Case File / Name: ASR-SR-35-2018 DSLC - Clark Avenue Condos

LOCATION:	This site is located on the west side of Enterprise Street, between Clark Avenue and Garden Place. The site is comprised of several lots being 2204 Garden Place, 101 Enterprise Street, and 2303 Clark Avenue.
REQUEST:	THIS IS A REVISION TO THE PREVIOUSLY APPROVED PRELIMINARY PLAN. Development of several parcels being recombined into one 0.719 acre parcel zoned OX-5-UL CU and within the Special Residential Parking Overlay District. The originally approved development was to be a 101,686 square foot, 51 unit condominium building with on-site parking. The approved revision updates the number of dwelling units (51 to 53), the square footage (101,686 to 99,634 sq. ft.), the size and location of sewer, fire, and domestic services, as well as the FDC. While the sunset date for this project (1/12/23) is unchanged and has passed, building permits were issued prior to that date in conformance with UDO Section

Design Adjustment Staff Response

ADMINISTRATIVE SITE REVIEW FOR CLARK AVENUE CONDOS 101 ENTERPRISE STREET, RALEIGH, NC 27607 1st Submittal: 04/11/18

TREE PLANTER DETAIL SCALE 1" = 5'

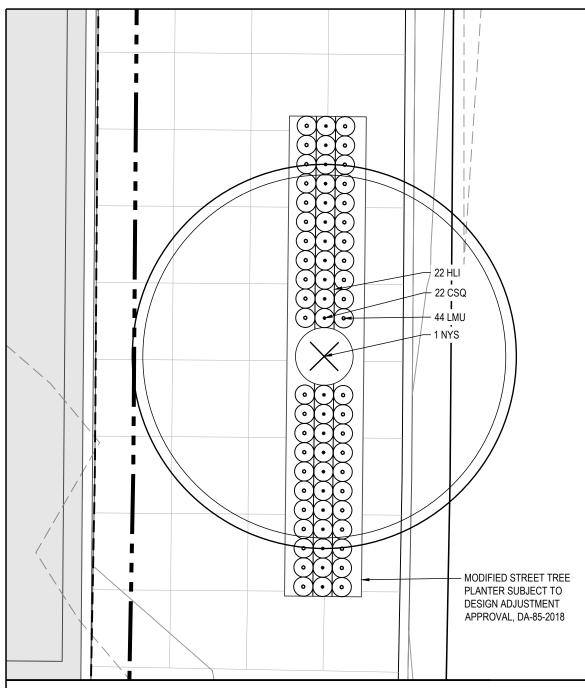
Staff supports the request for an altered planting area for the street trees along the frontages of Clark Ave and Enterprise St. The proposed change does not alter the UDO/RSDM required pedestrian walkway depth, but rather elongates the tree grate area. The previously approved development, S-63-17, has granted a Design Adjustment for this altered streetscape. By approving the altered streetscape, the block's streetscape will remain consistent in that area. There are no issues with pedestrian access or ADA accessible ramps at street crossings due to the altered streetscape.

The proposed 4' x 25' street tree planters will provide a larger area to accommodate growth than the typical 4' x 6' street tree grates. The proposed street tree planters are consistent with the cross-sectional dimensions specified in the Street Type Overview section of the Raleigh Street Design Manual.

There will be a 8' clearance behind the proposed street tree planters.

The proposed street tree planters eliminates cost and maintenance responsibilities of metal grates. No additional maintenance responsibilities will be required.
